World Forum for Harmonization of Vehicle Regulations**Working Party on Passive Safety****Seventy-fifth session**

UN Regulation No. 16 (Safety-belts)**Proposal for the [11] Series of Amendments of UN Regulation
No. [16] (Safety-belts)****Submitted by the experts of the Ad Hoc Group on Safety-belts Reminder***

The text reproduced below was prepared by the Safety-Belts Reminder (SBR) ad hoc group to address SBR-related issues in UN Regulation No. 16 raised by the expert of the Republic of Korea (GRSP 72-13). The modifications to the existing text of the UN Regulation are marked in bold for new or strikethrough for deleted characters.

Annex 18, paragraph 1, amend to read:

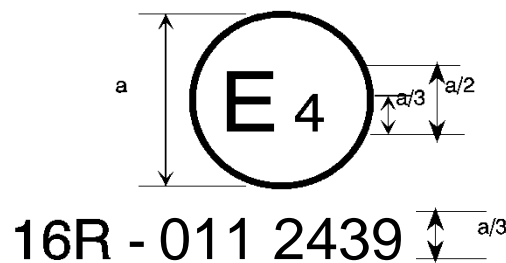
"1. The first level warning shall be tested according to the following conditions:

- (a) Safety-belt is not fastened;
- (b) Engine or propulsion system is stopped or idling, and the vehicle is not in forward or reverse motion;

- (e) — ~~Transmission is in neutral position;~~
- (~~d~~c) Ignition switch or **vehicle** master control switch is activated;
- (~~e~~d) A load of 40 kg is placed on each seat cushion in the same row as the driver's seat, or the state in which occupants are on board the vehicle is simulated by an alternative method specified
- (~~f~~e) The state of the safety-belt reminder is checked for all of the relevant seat(s), in conditions (a) to (~~e~~)(d)."

2. The first level warning shall be activated whether the transmission is in neutral position or not. Hence Annex 18; 1. (c) is deleted.
 3. For vehicles equipped without conventional devices to activate propulsion systems, "vehicle master control switch" definition is harmonized with other regulations, such as UN Regulation No. 159 and revised "master control switch" to "vehicle master control switch" in the text.
